DEVELOPMENT APPLICATION ASSESSMENT REPORT

Application Number:	DA2021/0931
----------------------------	-------------

Responsible Officer:	Gareth David
Land to be developed (Address):	Lot 5 DP 253614, 264 Hudson Parade CLAREVILLE NSW 2107
Proposed Development:	Alterations and additions to a dwelling house including a detached garage with studio
Zoning:	E4 Environmental Living
Development Permissible:	Yes
Existing Use Rights:	No
Consent Authority:	Northern Beaches Council
Land and Environment Court Action:	Yes
Owner:	David Albert Simpson Hayley Simpson
Applicant:	David Albert Simpson

Figure 1- Proposed building envelope non-compliance on south-eastern elevation (highlighted in green).

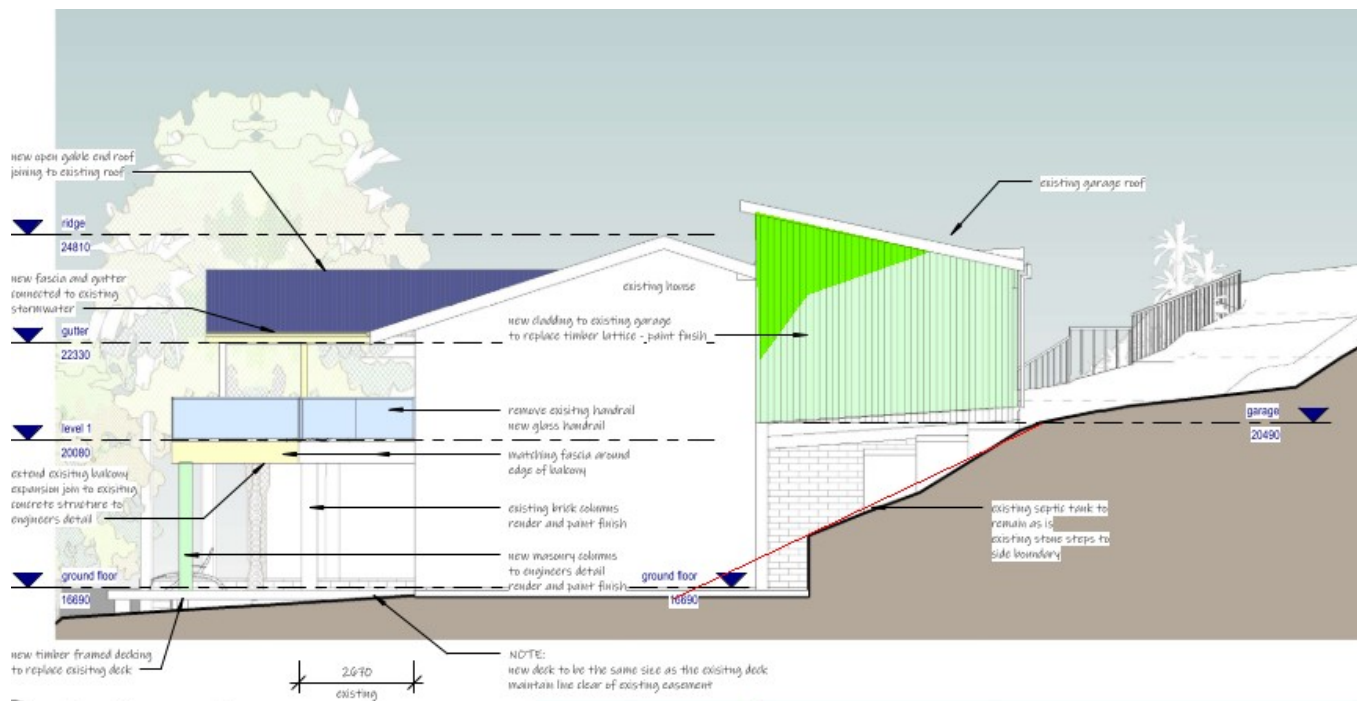
The proposed dwelling additions has a encroachment into the prescribed building envelope along the south-eastern elevation. This variation is represented in figure 1 below.

This building envelope non-compliance is largely attributed to the existing built form and the slope of the site, which exceeds 30%. P21DCP allows for a variation to the prescribed building envelope for development on steep sites, subject to consistency with the outcomes of this Clause. The area of non-compliance would be an enclosing wall to replace lattice screening on an existing carport.
